Windsor Bridge replacement project

Submissions report

Transport for NSW | February 2019

Figure 2-1: Proposed landscape improvements to Windsor Wharf Reserve

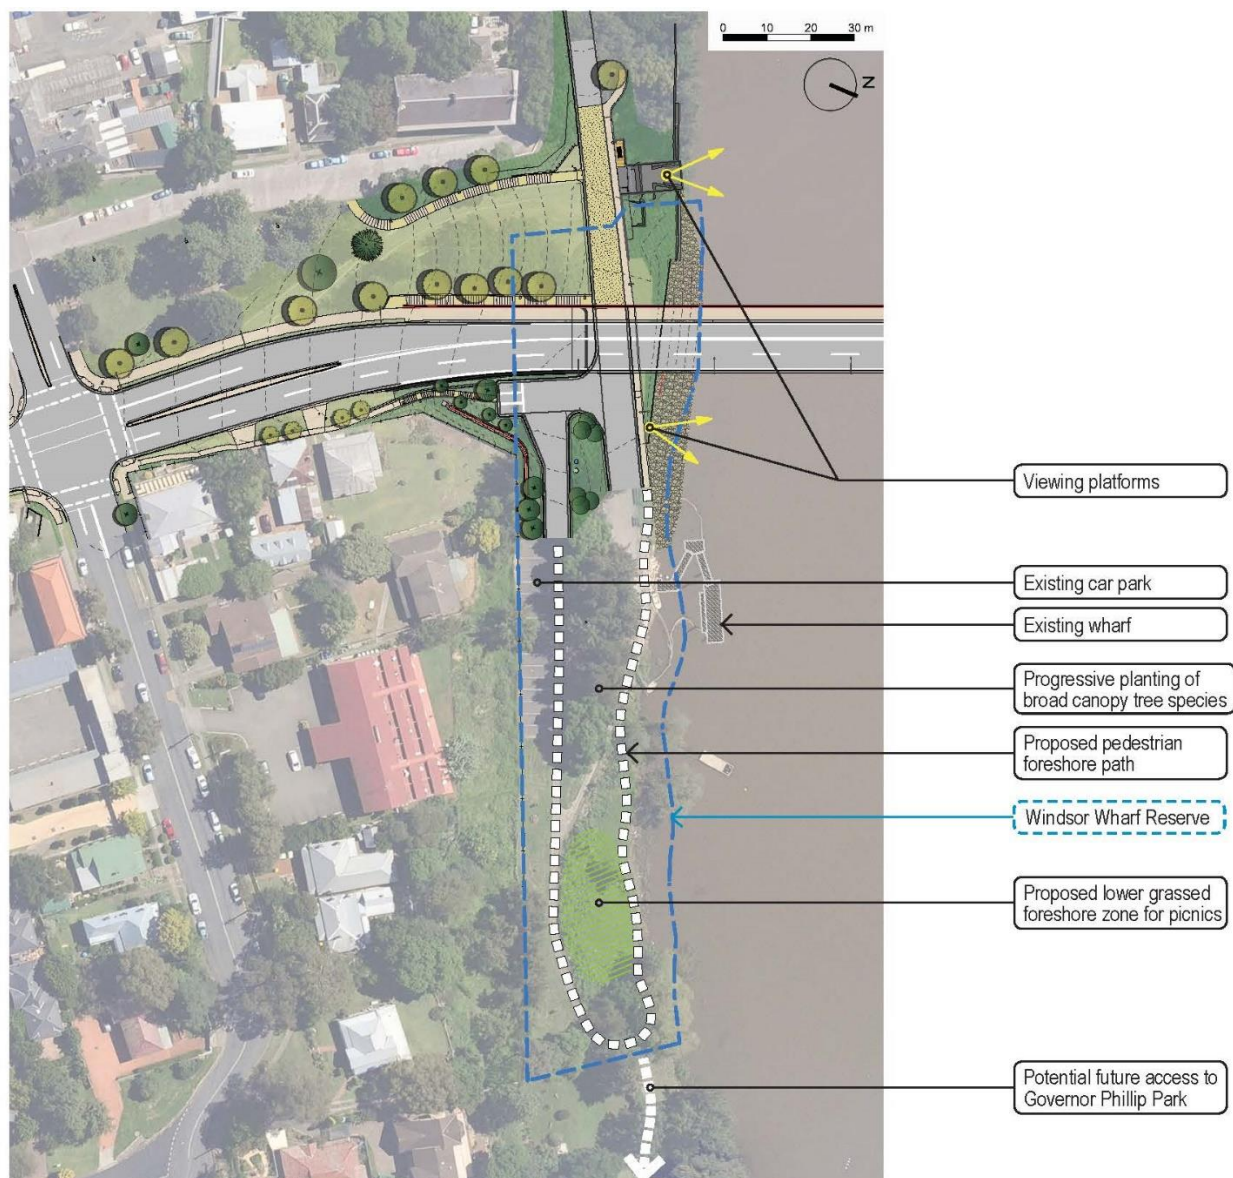
9. Concerns that the reduction in the area of Thompson Square parkland would negatively impact on the potential community benefits and economic benefits provided through heritage tourism to the area.
10. Comment about the reduction in the Archaeological buffer zone proposed as part of the modification.
11. Question about the heritage and character impacts of an additional northbound lane on the bridge.
12. Comment that the proposed modification is inconsistent with the original Conditions of Approval, which did not provide for further incursions into the Heritage Precinct of Thompson Square.

As part of the RTS process, Transport looked into an opportunity to improve the open space and amenity within the broader project area (refer Appendix F). Transport has identified a partnering opportunity with Hawkesbury City Council to upgrade the landscaping at the Windsor Wharf Reserve which adjoins the WBRP project area. These landscaping improvements were identified previously in Hawkesbury City Council's *Windsor Foreshores Parks Plan of Management Plan (PoM)* (Hawkesbury City Council, 2013) in addition to the proposed works for the WBRP. Figure 2-1 shows an aerial view of Windsor Wharf Reserve, identifying and the range of landscaping improvement works that are now proposed to be undertaken as part of the WBRP (including modification).

These landscape improvement works would provide a significant contribution to the foreshore open space in Windsor. The foreshore works in the Reserve also provide the opportunity to facilitate access and usage of this foreshore area, providing additional attractive riverfront parkland with foreshore picnic areas, a revamped Hawkesbury Artist Trail, vantage points to view the river and easy access to the wharf for patrons of the Hawkesbury Paddlewheeler and other boat users.

Figure 2-5: Comparison between approved and modified conditions – Cross sections

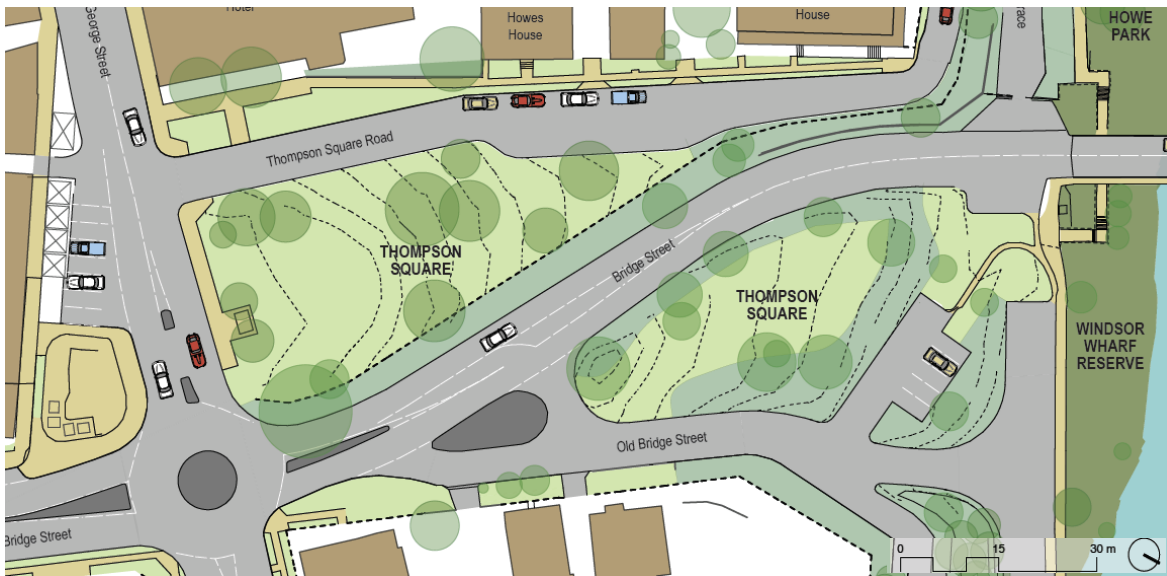
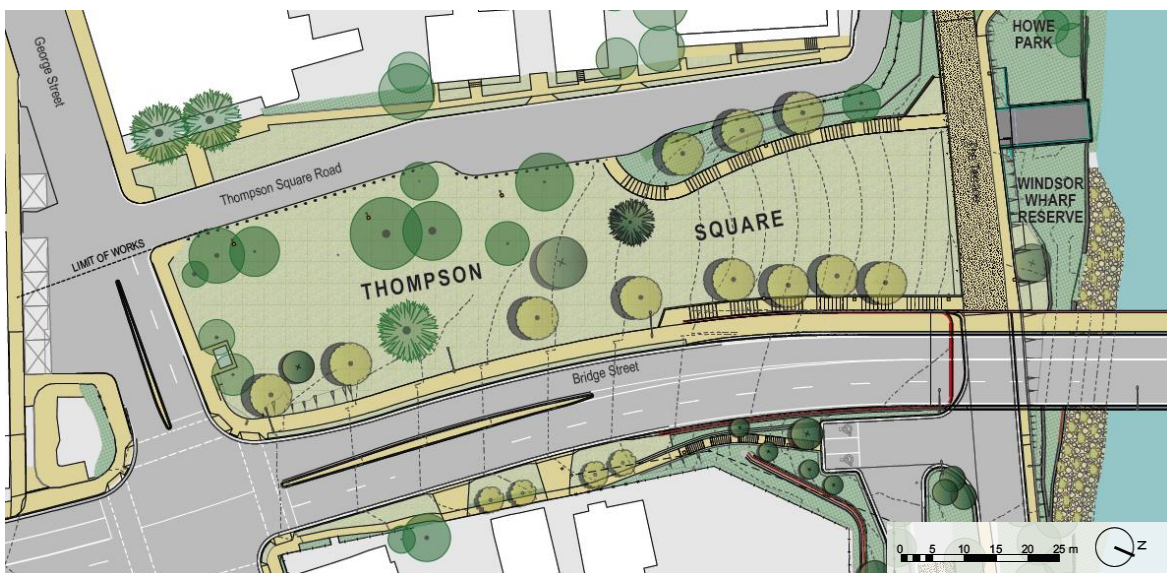
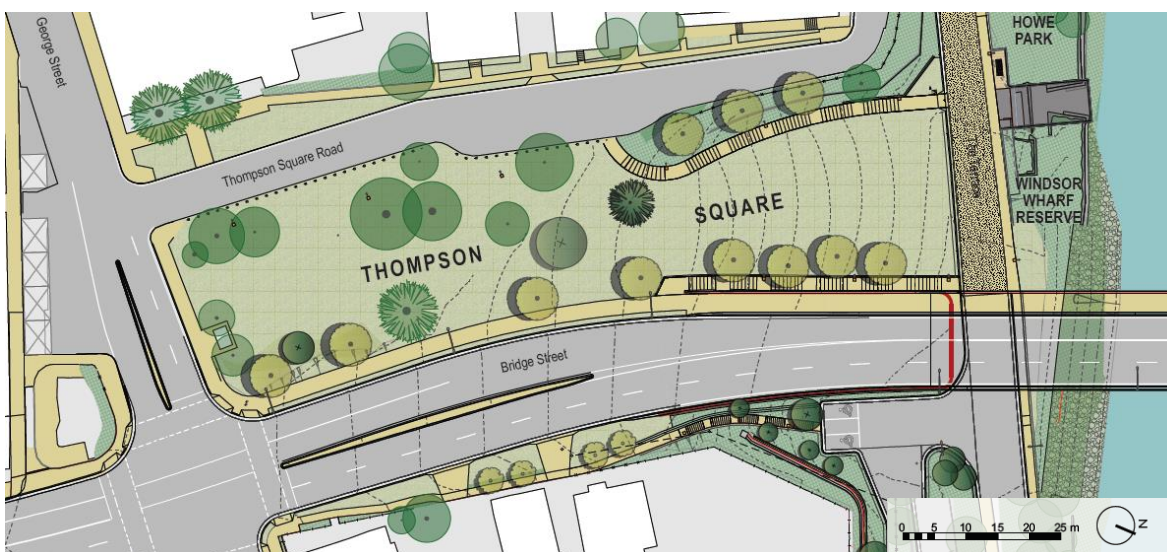
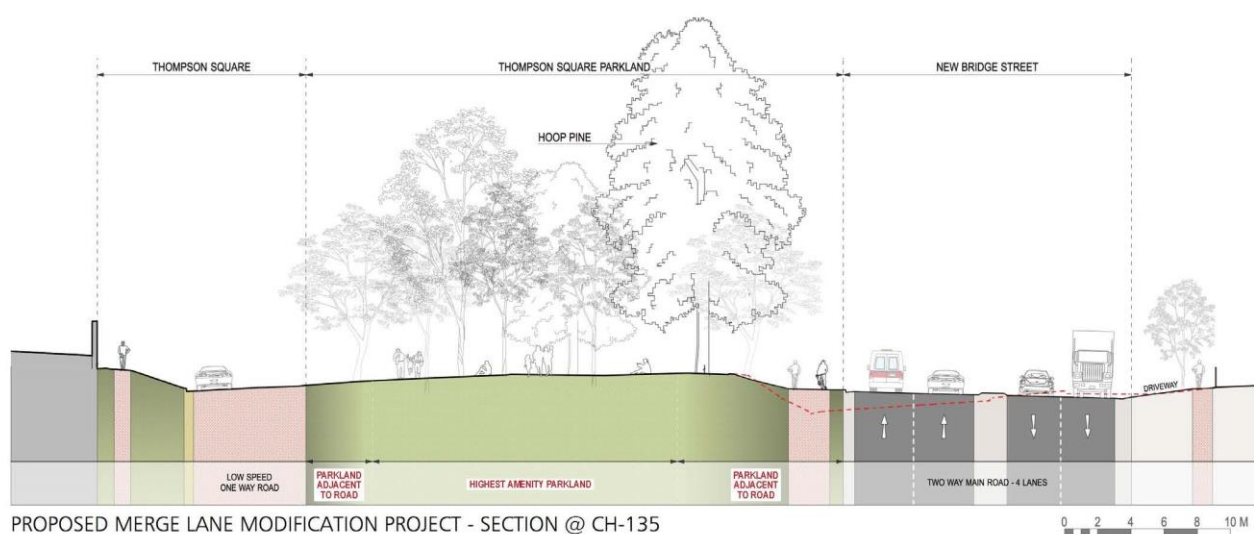
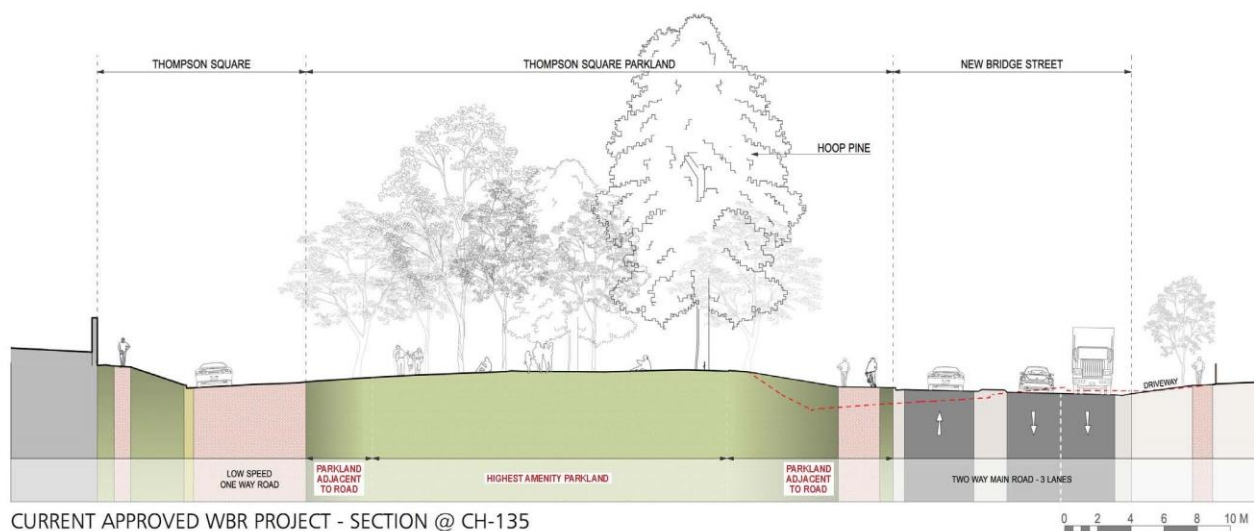
1. Comments that the Modification report fails to recognise the significant heritage value of Thompson Square Conservation Area.
2. Concerns over the further reduction in the area of Thompson Square parkland.

6. Concern about the cumulative impacts on Thompsons Square, and the further likely erosion of effective public heritage interpretation on the ground.
7. Comment that the excavation required to construct the new merge lane could disrupt historic tunnels under Thompson Square.

Transport acknowledges that the proposed modification would result in a reduction in parkland space (approximately 160 square meters) in the south east corner of Thompson Square compared to the approved project. However, there would still be an increase to the overall unified open space in Thompson Square parkland compared to the original conditions (i.e. without approved project or modification). The original condition is shown in Figure 2-2, the approved design is shown in Figure 2-3 and the proposed modification is shown in Figure 2-4. These figures clearly show the unification of the two original parkland areas of Thompson Square, with the river foreshore parks of Howe Park and Windsor Wharf Reserve as a result of both the approved project and the proposed modification. A detailed summary of the design development is provided in Appendix F.

Section 4.3 of the Modification report describes the footprint of the modification on the parkland as a narrow and tapering strip of land in the south east corner of Thompson Square. The strip of land would measure between zero and 3 metres in width over a length of 100 metres. Figure 4.4 of the modification report also shows the widening for the merge lane is centred around and located to the east of the significant Hoop Pine in Thompson Square.

The location of the widening has been assessed in the Supplementary Landscaping Information (refer to Appendix F) to be in an area which separates the higher amenity value parkland central core from the adjacent Bridge Street. This area of land is sloping towards the roadway and the shared pedestrian/ cycle path and is seen as having lesser public space amenity. The cross sections of the parkland shown in Figure 2-5 shows the flatter land in the Upper Parkland to the west of the Hoop Pine to be the area of highest amenity value. This central core area of parkland is not directly affected by the proposed modification.

Also as shown in the cross sections in Figure 2-5, the original conditions at this location included a steep cutting face which impacted the open space amenity of this area. By backfilling and landscaping the former cutting both the approved project and the proposed modification provide a higher level of open space amenity than the original conditions.
